Safety Evaluation Report

Offshore Power Systems Floating Nuclear Plants (1 - 8)

Docket No. STN 50-437

SUPPLEMENT NO. 3

FIGURE 9

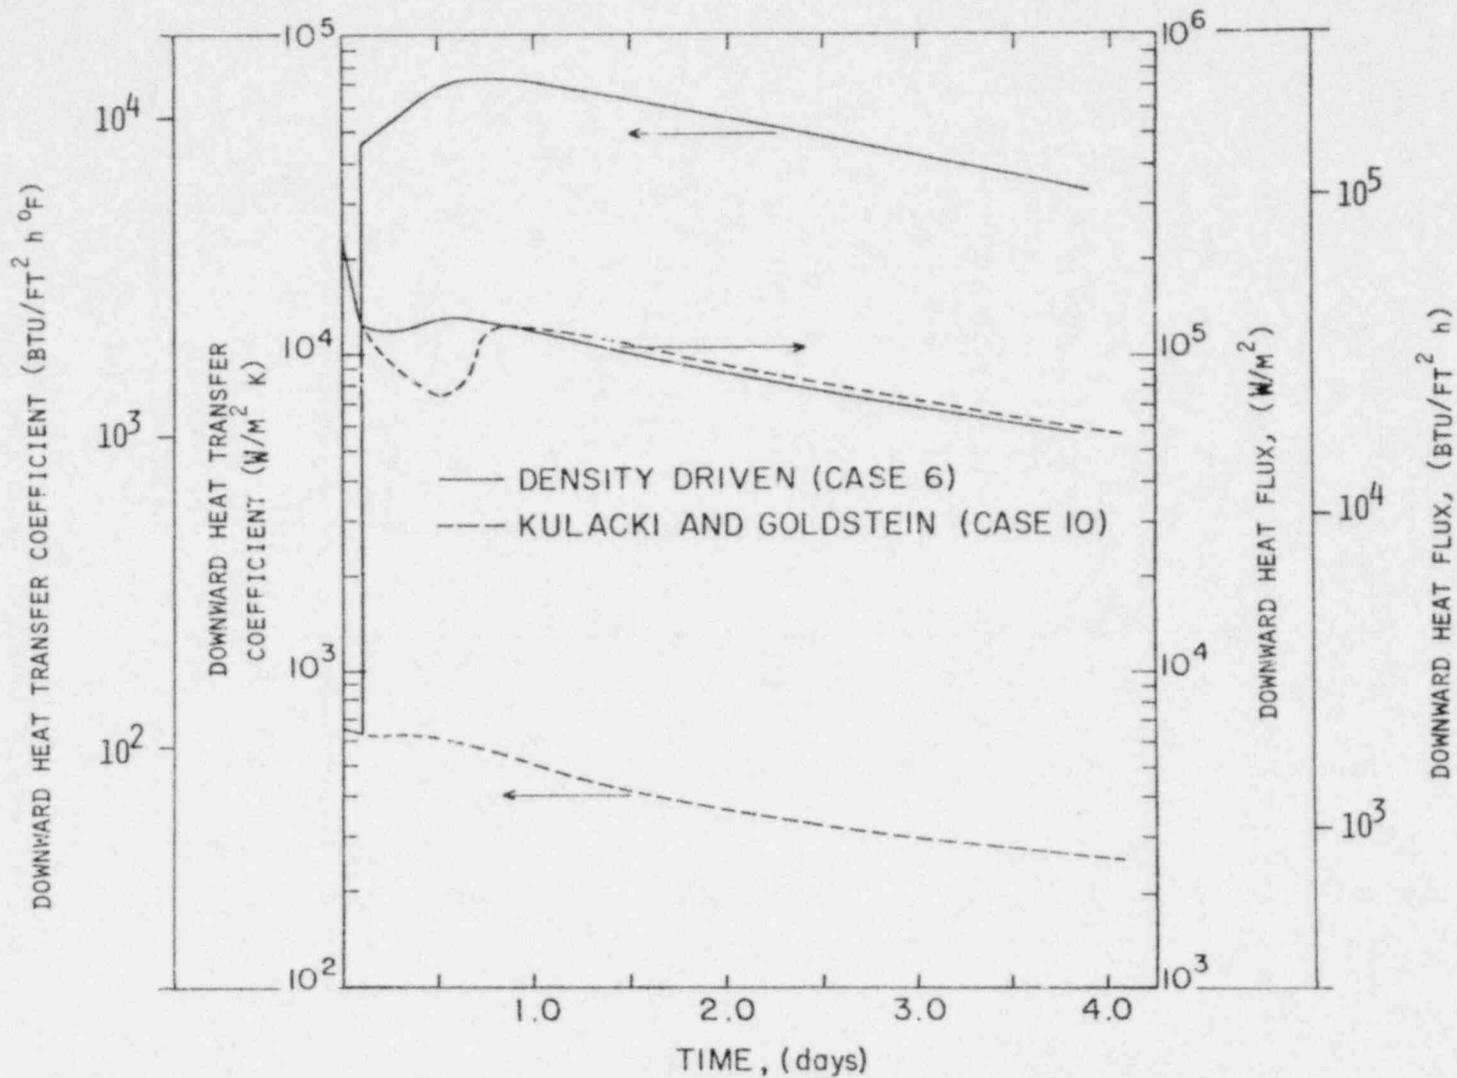
Figure 9 shows the heat transfer coefficients and downward heat fluxes for these two cases. Although the heat transfer coefficient for Case 10 is two orders of magnitude less than that for the density-driven case (Case 6), the downward heat fluxes are not radically different. The reason for this can be seen in Figure 10. Apparently, the decrease in downward heat transfer (by a factor of 10^{-2}) causes the system to respond by raising the pool temperature 200 degrees Kelvin (360 degrees Fahrenheit). This is an effective increase in the pool-to-bottom-surface temperature differential of, again, about two orders of magnitude, so that the net difference in heat flux is small.

FIGURE 11
 Effect of Heat Transfer Correlations on Core Ladle Penetration

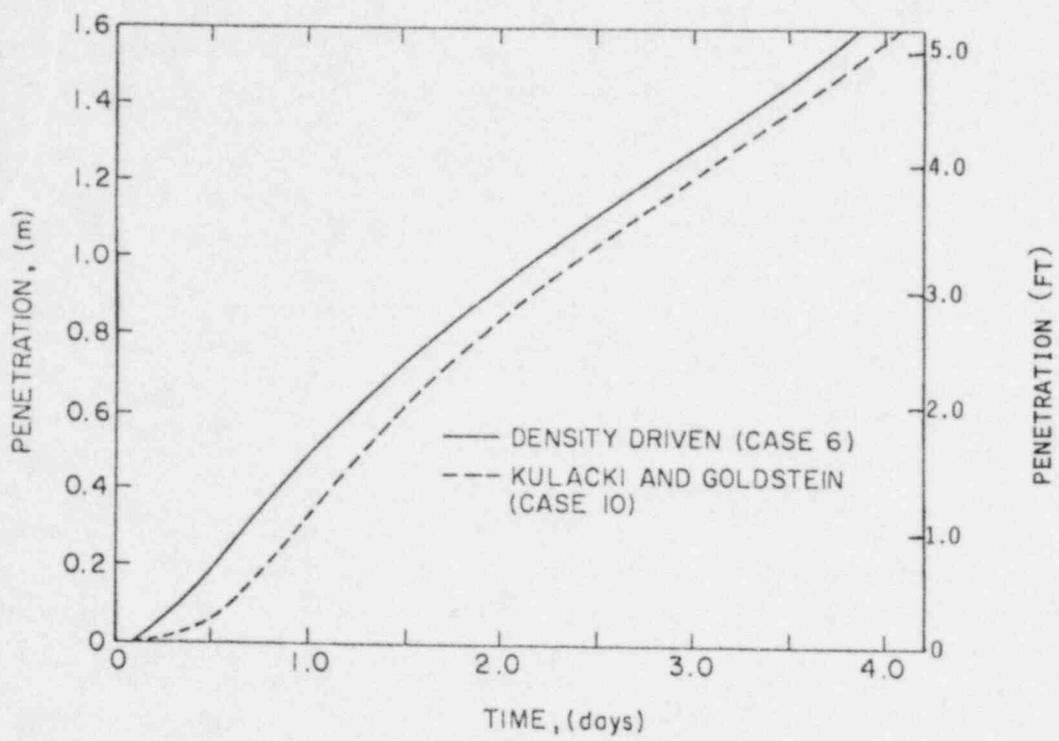
With the downward heat fluxes comparable for Cases 6 and 10, it would be expected that the penetration rate would be similar. Figure 11, indeed, shows this to be the case. The core ladle is penetrated in 4.1 days for Case 10 and 3.9 days for Case 6. The obvious conclusion here, is that barring extreme changes in the pool temperature, which might shift the upward radiative heat transfer, the penetration rate does not seem to be sensitive to the downward heat transfer coefficient.

FIGURE 12

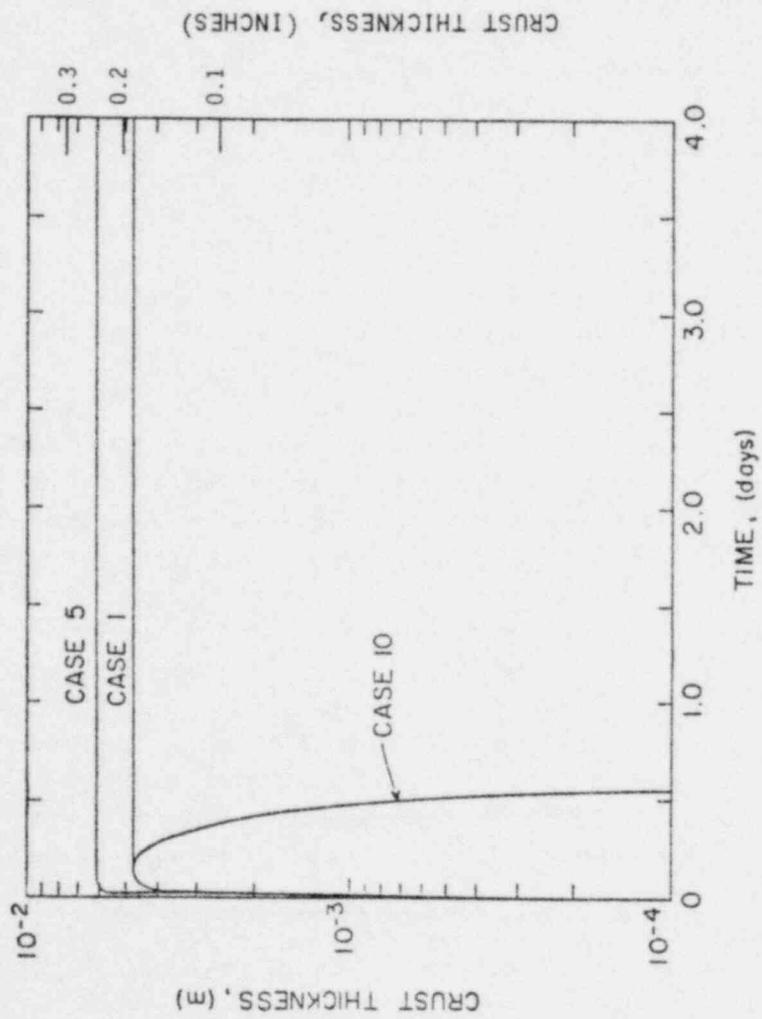
The crust thickness for Cases 1 and 5 can be seen in Figure 12. The difference in the crust thicknesses is even more apparent during the initial part of the transient when the solidification rate is significantly greater for Case 5.

FIGURE 13
Effect of Cavity Wall Configuration on Concrete Temperature

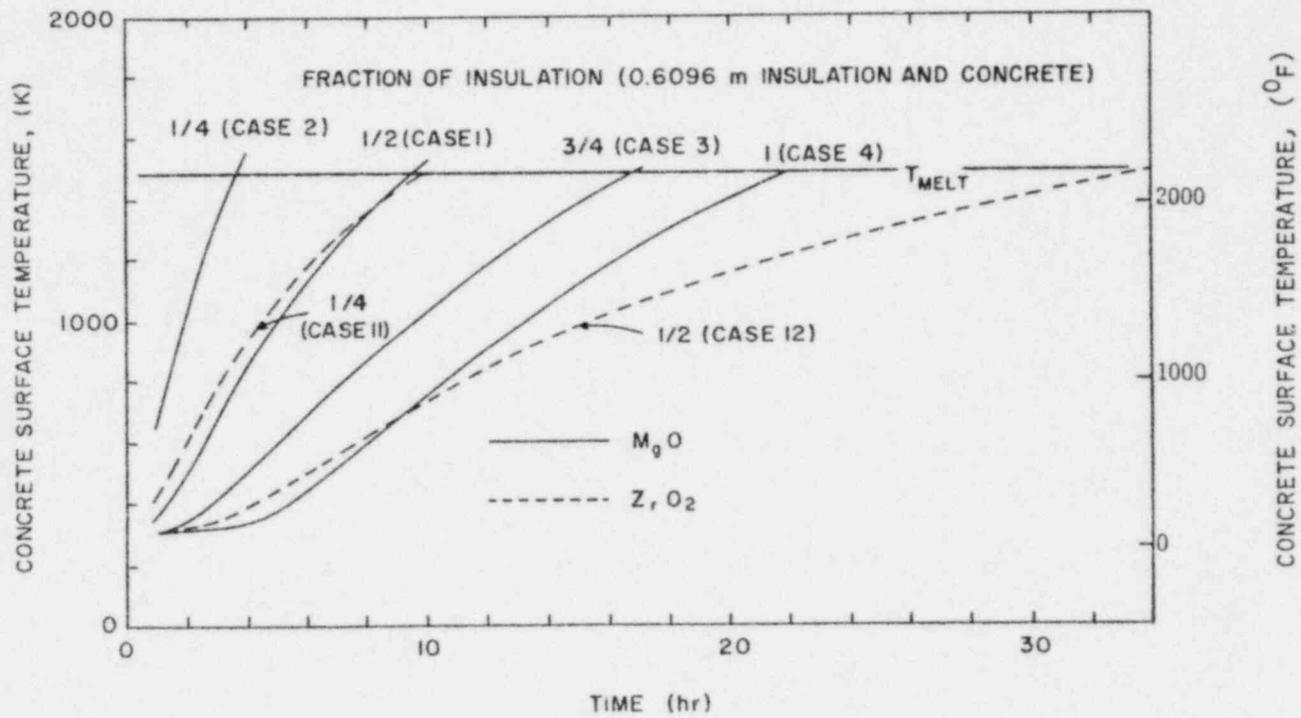
Two additional cases (Cases 15 and 16) were run using the same general configuration (2 feet of wall) and substituting ZrO_2 in place of MgO. The ZrO_2 has a significantly lower thermal conductivity and, as is shown in Figure 13, with one foot of ZrO_2 protecting the concrete, it can be maintained below the melting temperature out to about 1.4 days. With 1-1/2 feet of ZrO_2 and 1/2 foot of concrete, the concrete could probably be protected out to 2 days. However, an additional problem is encountered with the use of ZrO_2 . Its melting temperature is about 123 degrees Kelvin (221 degrees Fahrenheit) lower than that of MgO with the result (as shown in Figure 14 (broken line - Case 15)) that the ZrO_2 begins to melt at about 2 days.

FIGURE 14

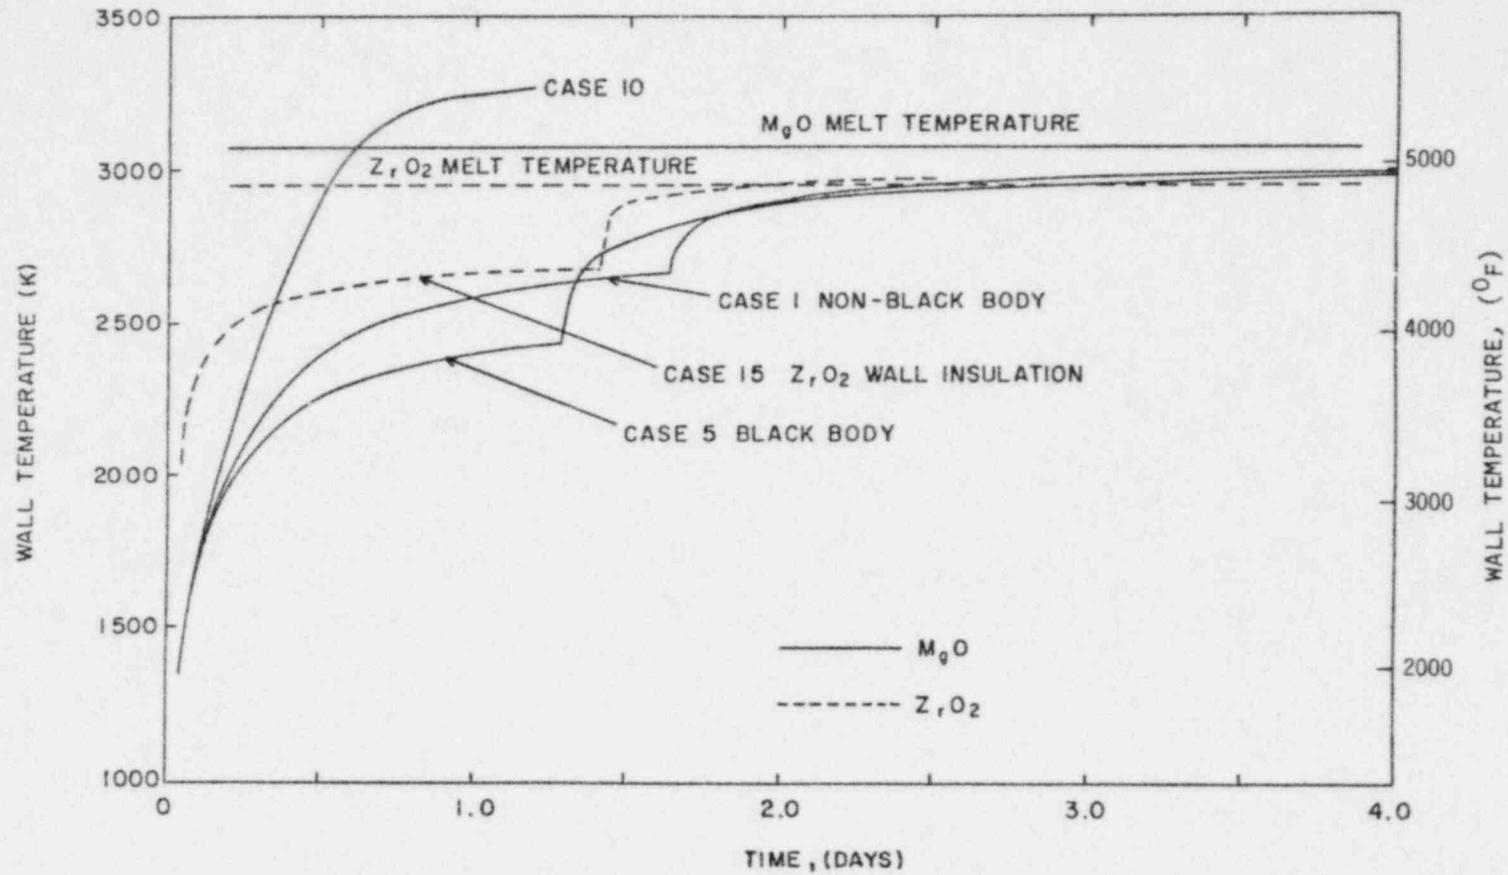
Figure 14 also shows the wall surface temperature for a selection of cases which have been previously discussed. The MgO wall insulation was threatened only in Case 10. In Case 10, downward heat transfer was limited to the Kulacki-Goldstein correlation. The extremely high pool temperature and upward radiation heat fluxes brought the wall to the melting temperature in about 0.6 days. The sudden changes in the slope of the temperature curves in Figure 14 correspond to the times at which the reactor vessel has been completely melted. When the heat sink available in the vessel is gone, the heat flux from the pool decreases which results in an increase in the pool surface temperature and ultimately in an increased heat flux to the cavity wall.

FIGURE 15
 Fraction of Integrated Decay Heat Absorbed by
 Cavity Walls and Reactor Vessel

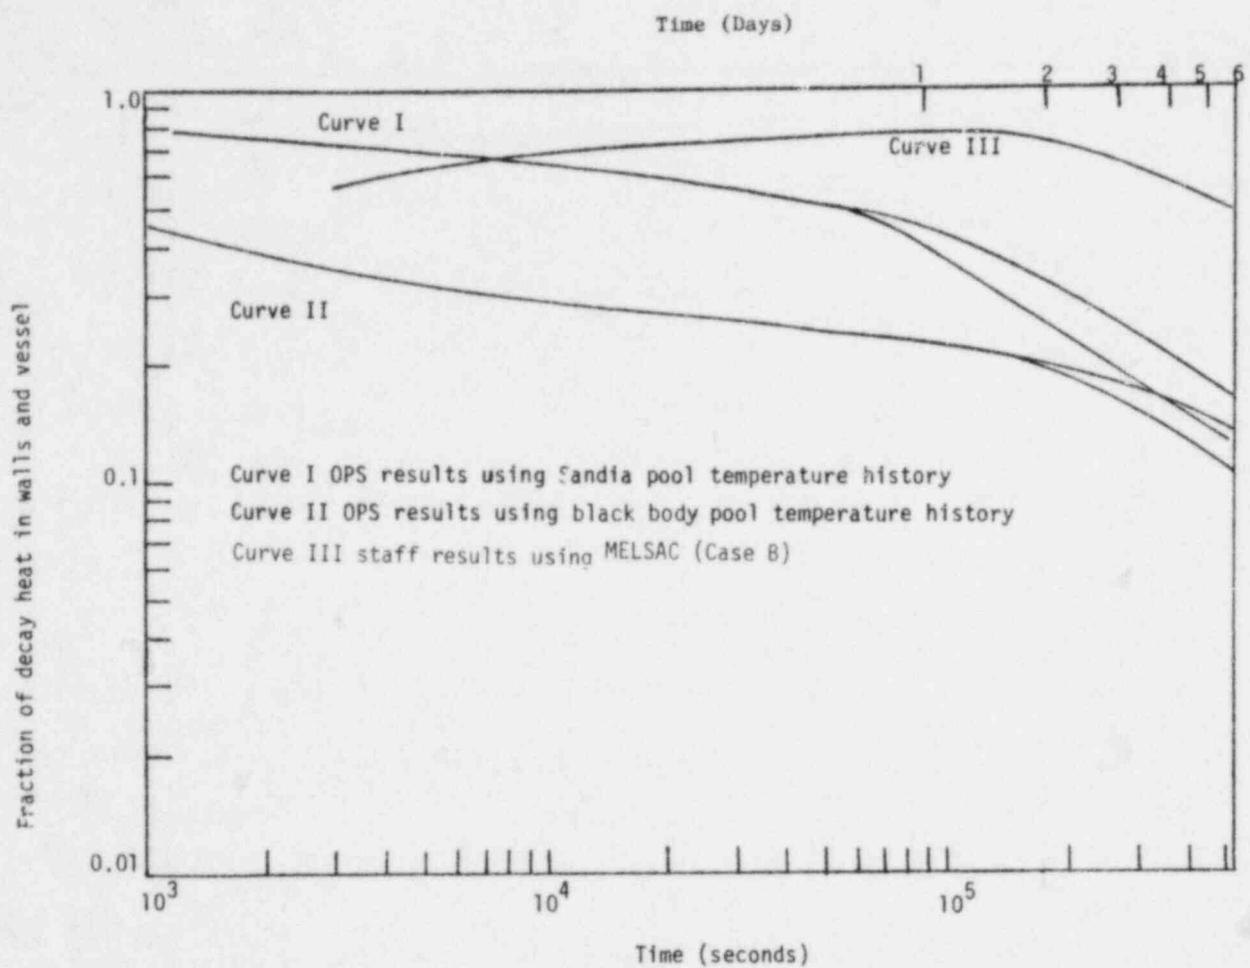
Regarding Question a.1 in which the ACRS requested an estimation be made of the fraction of the decay heat radiated upwards from the pool, we have plotted the fraction predicted by MELSAC for Case B in Figure 15. The MELSAC result is also compared with the results provided by OPS in Figure 15. After one day, the fraction of heat stored in the walls and vessel ranges from 0.25 to 0.46 using OPS assumptions, whereas MELSAC predicts the heat stored to be 0.76. Similarly, after 5.79 days (melt-through for Case B) MELSAC predicts a fraction 0.5 in the walls and vessel compared with 0.11 and 0.17 at 6 days using OPS assumptions.

Erosion Depth as a Function of Time
after Start of MgO Melting

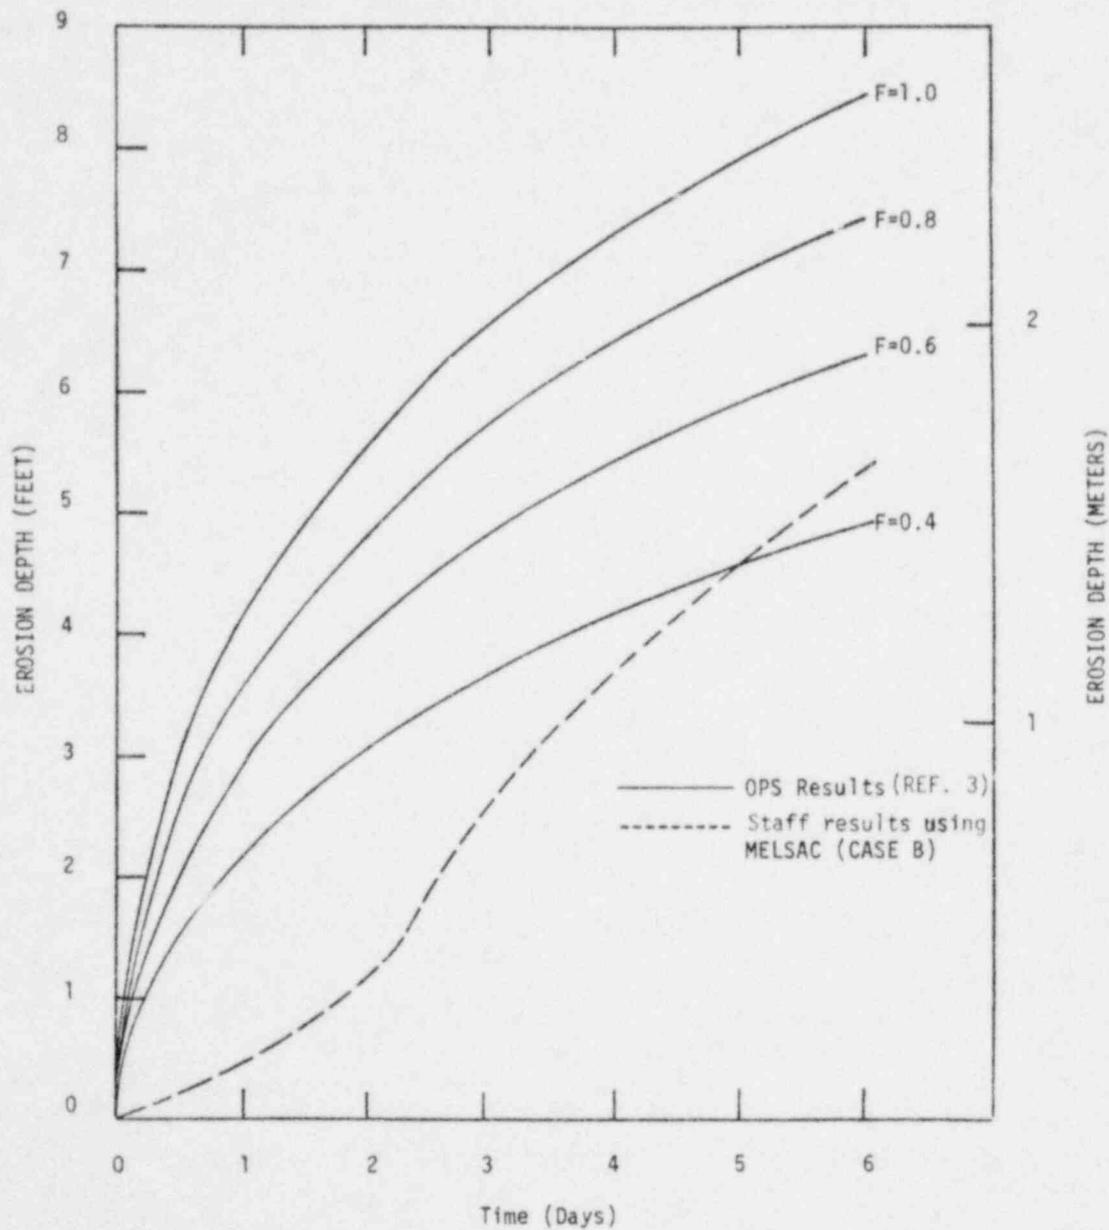
first week following the accident. Appendix E of Reference 1 supports the assumption that interdiction methods could be effectively used after that time. The findings illustrated previously in Figure 16 showing erosion depth as a function of time may be interpreted as an estimate that the FNP core ladle is capable of reducing the radiological environmental impacts of the FNP to levels comparable with those of land-based plants.

FIGURE 1 POOL TEMPERATURE HISTORIES PREDICTED BY MELJAC

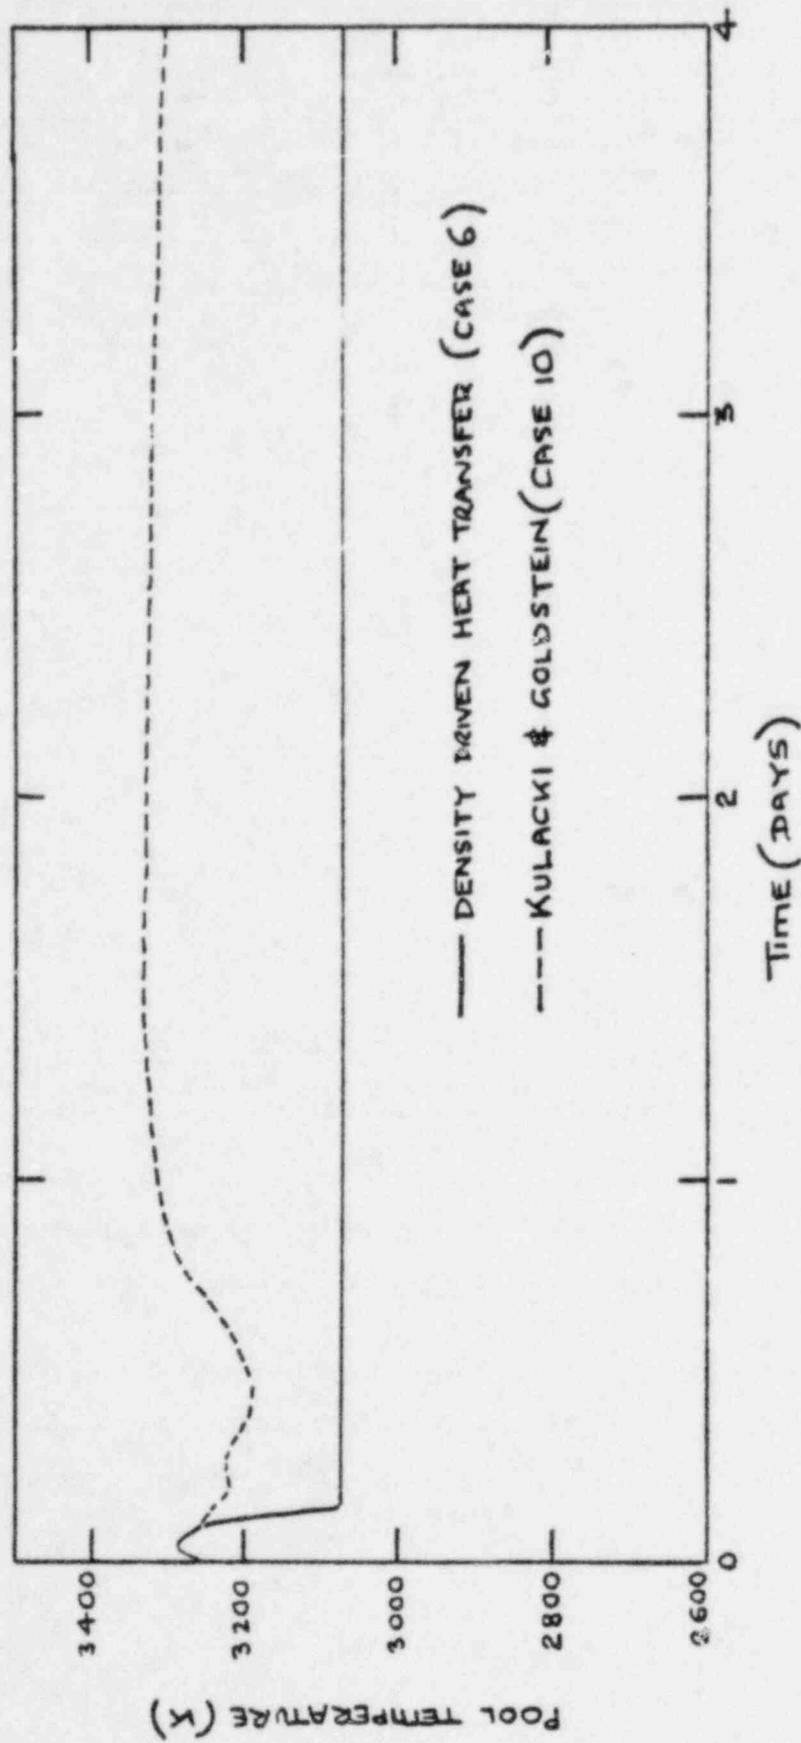
The temperatures shown in Figure 1 are the bulk pool temperature; the upper pool surface temperature is typically 80 to 100 K below this value. The effect of the higher surface temperature history predicted by MELSAC is to transfer more heat to the upper structures. A typical run (Case B) using MELSAC is compared with the results provided by OPS in Figure 2. After one day the fraction of heat stored in the walls and vessel ranges from 0.24 to 0.46 using OPS assumptions, whereas MELSAC predicts the heat stored to be 0.76. Similarly, after 5.79 days (melt-through for Case B) MELSAC predicts a fraction of 0.5 in the walls and vessel compared with 0.11 and 0.17 at 6 days using OPS assumptions. The result of this additional heat transfer to the walls is that MELSAC predicts (Case A) that the concrete in the cavity wall (24" MgO, 3" gap, 21" concrete) will reach its decomposition temperature (1473 K) after only 1 day. In order to determine a wall configuration that protects the concrete (<1473 K) and steel bulkheads (<810 K) beyond the two-day period, a scoping study was carried out and the results are presented in Table 2. MELSAC, predicts (Case B) that a MgO wall of 36" thick would be required to protect the concrete and steel for 2 days, given the input assumptions listed in Table 2.
